**Re: Lot 2 Block 3 Unit 18 Volcano Cliffs, S.A.D. 228
6612 Cuervo Pl NW
Request for Permanent C.O. – Not Accepted
Engineer's Stamp Dated: 10-29-19 (D0D003S2)
Certification dated: 6/12/2020**

Based on the Certification received 8/18/2020, this site cannot be accepted for release of Certificate of Occupancy by Hydrology until the following comments are addressed.

**LOT 2, BLOCK 3, UNIT 18
VOLCANO CLIFFS SUBDIVISION**

JOHNSON (MIKE SANCHEZ) - 6612 CUERVO GRADING & DRAINAGE PLAN

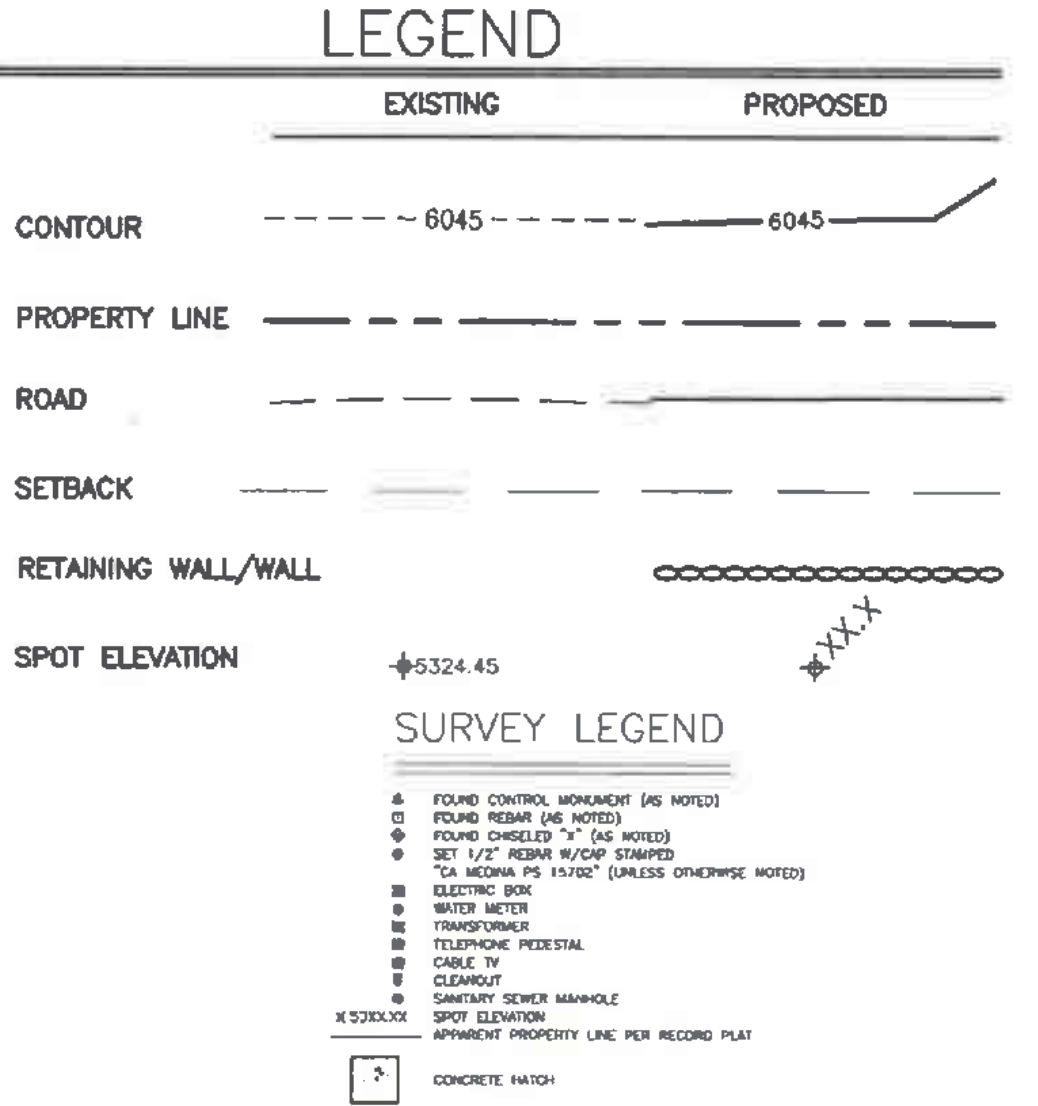
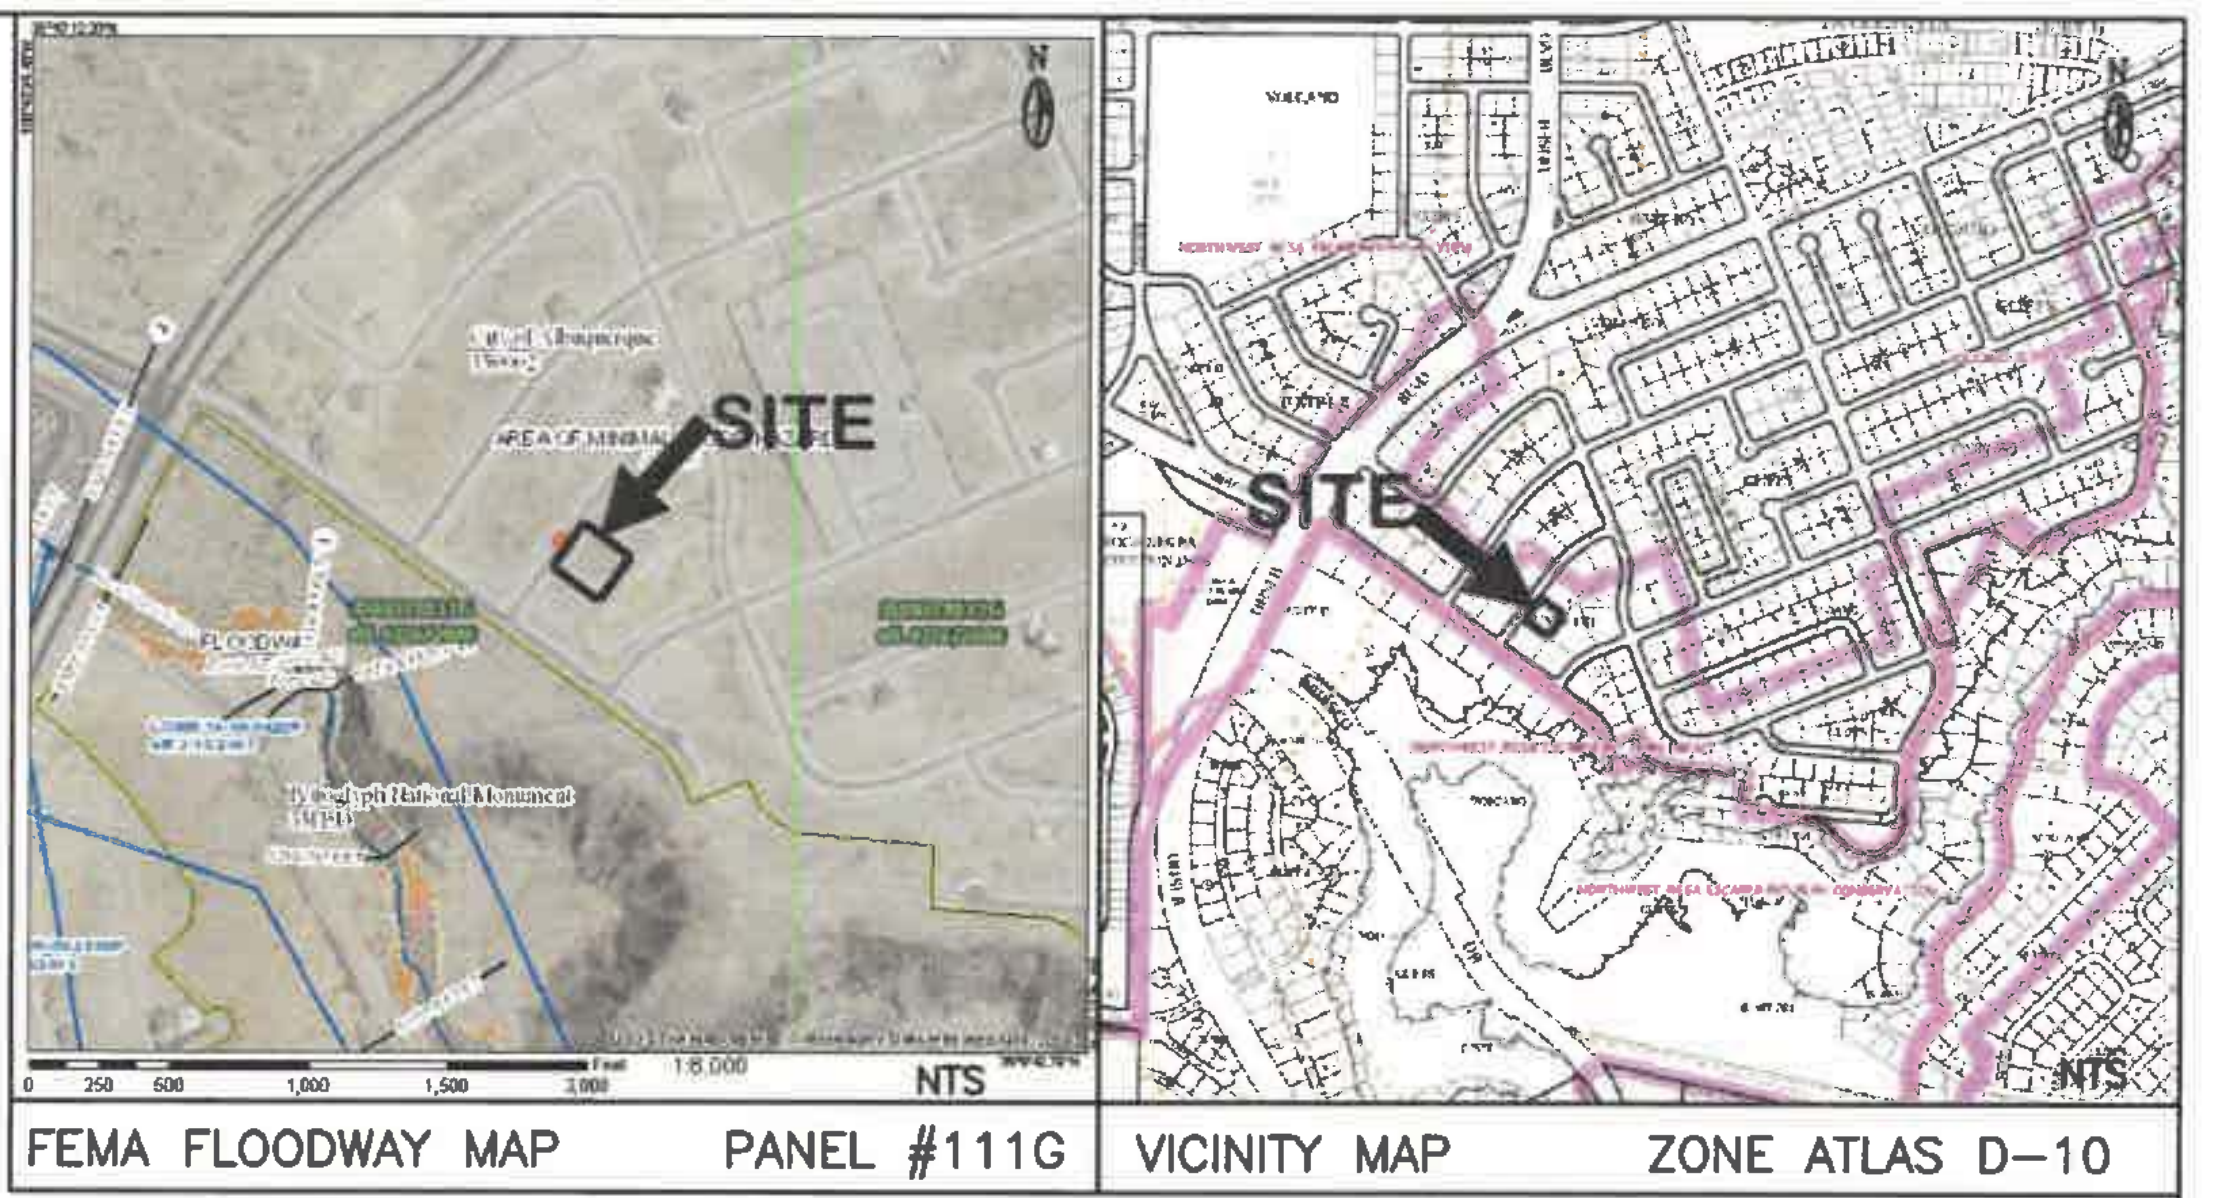
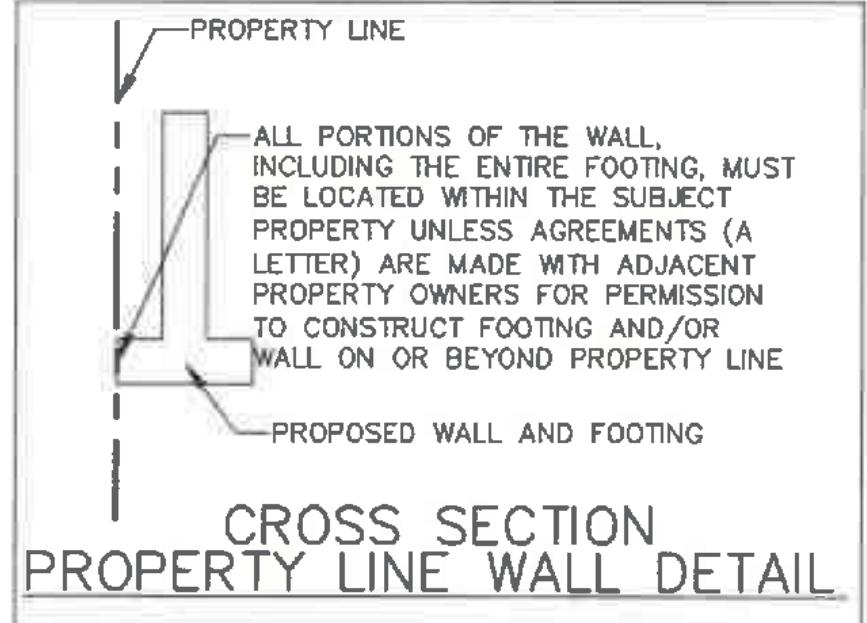
- Provide how erosion will be prevented on the east side of property, outside the block wall.
